To: INCITS Technical Committee T10
From: Gideon Avida, Decru
Date: Dec. 14, 2006
Document: T10/06-389r4
Subject: Using Public-Key Cryptography for Key Wrapping

5 Proposed changes to SSC-3 (based on ssc3r03a)

Figure X: Simple Deployment Environment

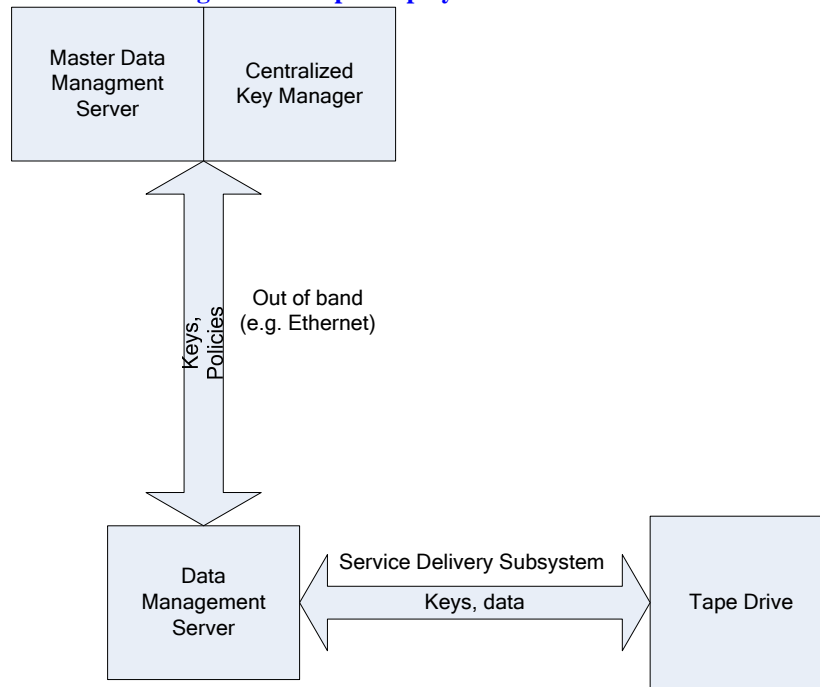
5.2 Add 4.2.x Protection of Data Encryption Keys

4.2.x.1 Data Encryption Key Protection Overview

A device server that supports data encryption should protect data encryption keys from disclosure. Key disclosure may be mitigated by several countermeasures such as key wrapping and/or securing the channel used to transmit the key.

4.2.x.2 Security Environment

The following diagram is meant to portray a typical deployment, in which a large number of device servers are being accessed by a set of data management servers, each set controlled by a master data management server. The addition of encryption in the device servers introduces a Key Manager (which may or may not be part of the master data management server). Organizations will have a centralized key manager for the same reason that they use master data management servers, although there is no requirement that only one such is used, but rather that relatively few key managers are installed in an environment with a relatively large number of device servers and data management servers.
